# UNITED STATES PATENT AND TRADEMARK OFFICE

APPLICATION NO.	FILING DATE	FIRST NAMED INVENTOR	ATTORNEY DOCKET NO.	CONFIRMATION NO.
10/068,062	02/05/2002	Ming-Hui Chou	P-3641.177	8329

## Office Action Summary

DETAILED ACTION

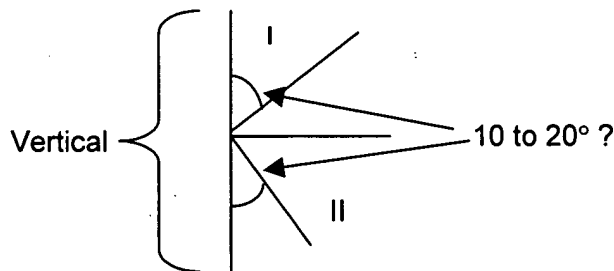
3. Claim 7 is rejected under 35 U.S.C. 112, second paragraph, as being indefinite for failing to particularly point out and distinctly claim the subject matter which applicant regards as the invention. Applicant fails to particularly describe the orientation of the extraction pipes in the top precipitation zone in relation to "from vertical to the surface level". Examiner is uncertain whether the extraction pipes are oriented 10 to 20 degrees in the direction of Quadrant I or Quadrant II.

Poole [U.S. Patent No. 2,273,660] Figure 3

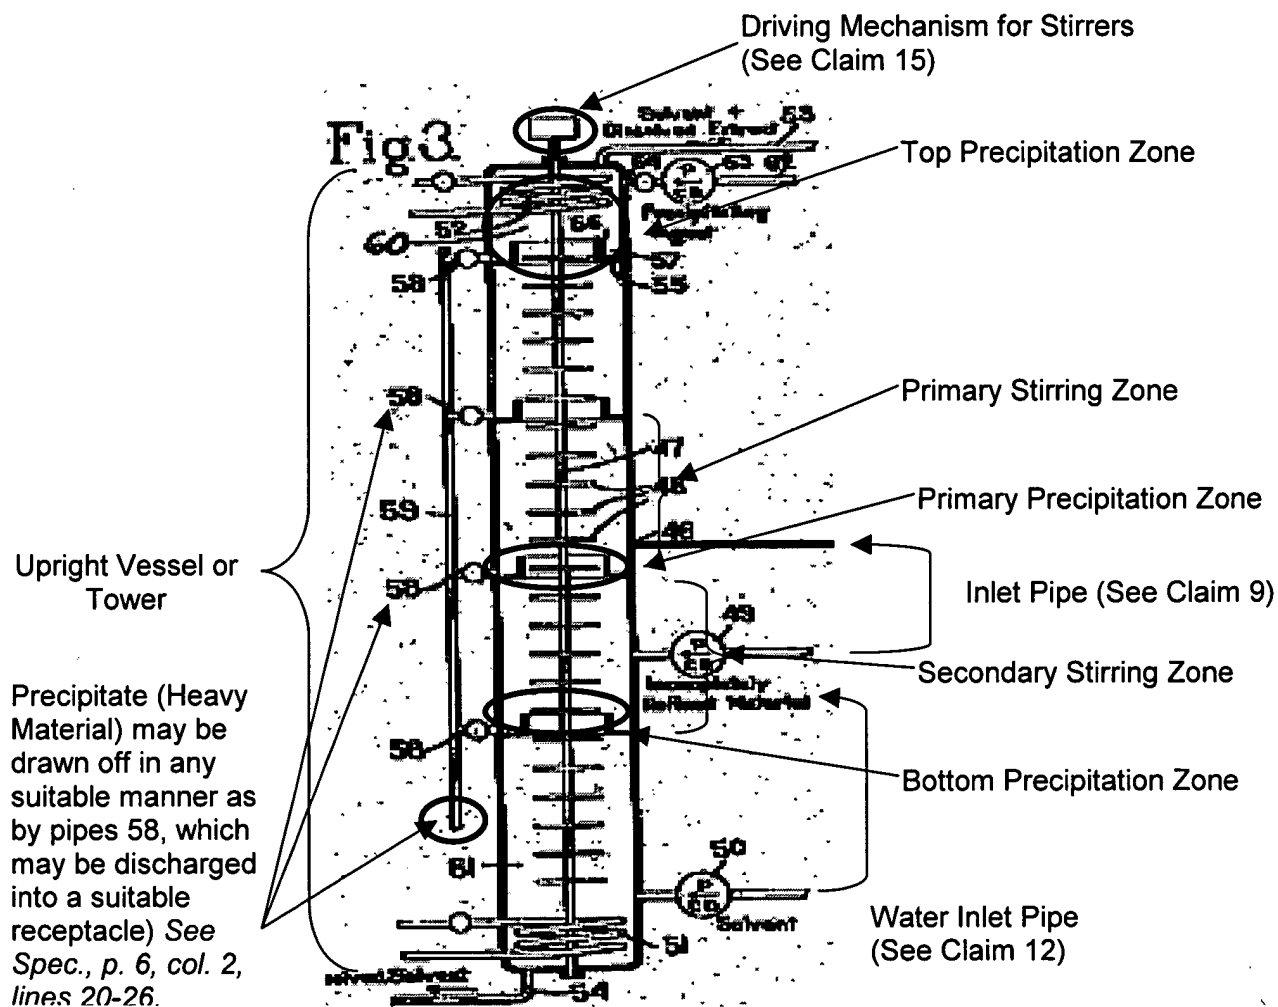
Regarding claim 1, Poole teaches a separation device, comprising: a tank (See Figure 3; upright vessel or tower 46) with multiple stirring zones (See Figure 3; series of mixing arms or paddles 48), multiple precipitation zones alternately arranged with the stirring zones (See Figure 3; See Specification, p. 6, col. 2, lines 8-16 – one or more annular catch basins 57 alternately arranged with the series of mixing arms or paddles 48), an outlet in a top portion of the tank (See Figure 3; discharge pipe 53), an inlet defined adjacent to the outlet (See Figure 3; inlet pipe 62), and a water inlet defined in the bottom portion of the tank (See Figure 3; solvent inlet pipe 50); and a collecting tank engaged with and communicating with the tank (See Figure 3; See Specification, p. 6, col. 2, lines 20-23 – this heavier material may be drawn off in any suitable manner as by pipes 58, which may be discharged into a suitable receptacle, e.g. a collecting tank for the precipitation), wherein each precipitation zone has an extraction pipe (pipes 58) and each stirring zone has stirring blades (mixing arms or paddles 48).

Poole fails to teach that each precipitation zone has multiple extraction pipes. It would have been obvious to one of ordinary skill in the art to provide each precipitation zone with multiple extraction pipes because multiple extraction pipes would allow for a larger concentration of precipitate or heavy material to be collected in the collection tank.

Regarding claim 4, Poole teaches the separation device as identified in claim 1 above, wherein the separation device comprises multiple alternating stirring and precipitation zones (See Figure 3 below; See Specification, p. 6, col. 1, line 59 to col. 2, line 16 – series of mixing arms or paddles 48 and one or more annular catch basins provided intermediate of the length of the tower). Figure 3 discloses one embodiment with four (4) stirring zones alternately arranged with four (4) precipitation zones. As described in the specification, Poole could comprise only two (2) stirring zones alternately arranged with three (3) precipitation zones. Thus, Poole further teaches the separation device as claimed in claim 1, wherein the tank (upright vessel or tower

46) is sequentially divided into a top precipitation zone, a primary stirring zone, a primary precipitation zone, a secondary stirring zone, and a bottom precipitation zone (See labeled Figure 3 below).

Poole fails to disclose a concentration zone, wherein the concentration zone is defined in the collection tank. It would have been obvious to one of ordinary skill in the art at the time the invention was made that the collection tank (See Specification, p. 6, col. 2, line 23 – suitable receptacle), as described in claim 1 above, would comprise an area within the receptacle suitable for holding the precipitate (heavy material) withdrawn from each precipitation zone.
